MONTGOMERY COUNTY PLANNING DEPARTMENT
THE MARYLAND-NATIONAL CAPITAL PARK AND PLANNING COMMISSION

MEMORANDUM

REVIEW TYPE: Preliminary Plan Review, Resubdivision

PROJECT NAME: Boyds Highlands
CASE #: 120070670
REVIEW BASIS: Chapter 50, Montgomery County Subdivision Regulations

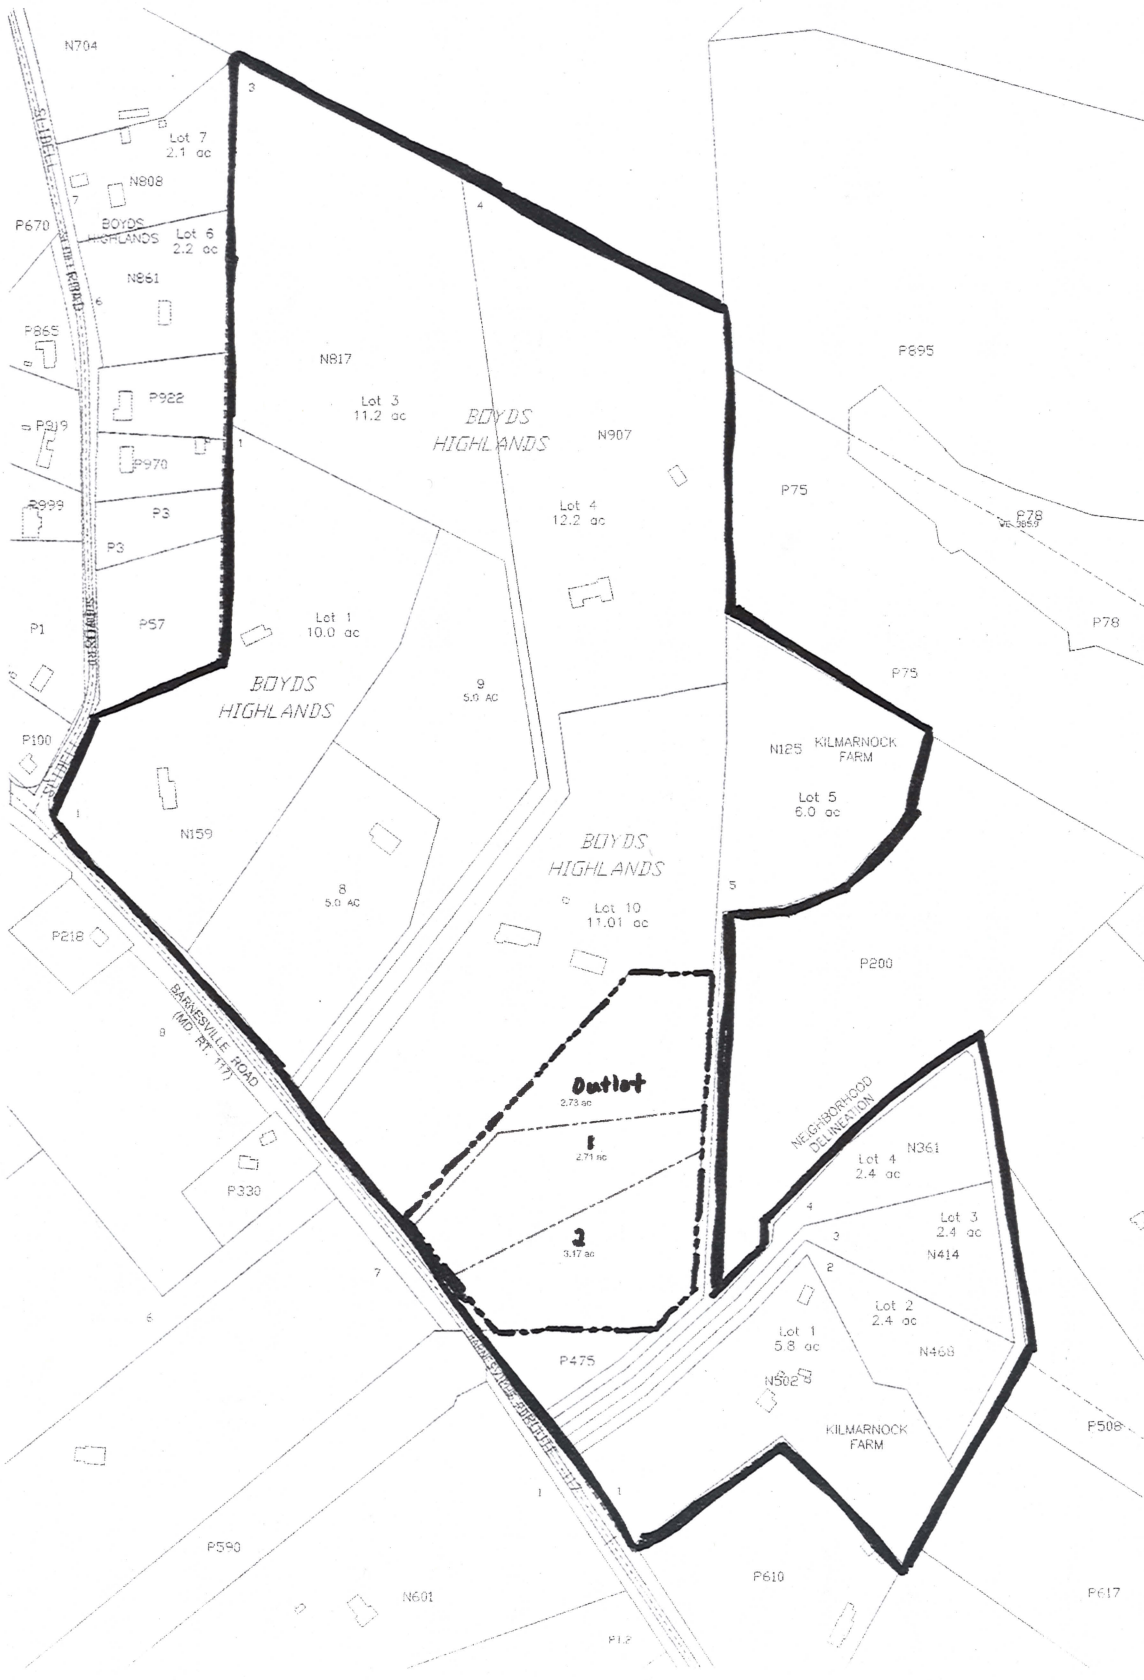
- Three separate driveway entrances are proposed. The applicant should revise the plans to consolidate the MD 117 access to one (1) use-in-common driveway for lots 1 and 2.
• The applicant must submit a sight distance evaluation on SHA worksheets.
• SHA will support any recommendations from M-NCPPC to widen MD 117 to provide a shoulder for bike compatibility.
• Access from MD 117 is subject to the terms and conditions of a residential access permit, which must be received from SHA's District #3 Utilities Office - 301-513-7350.
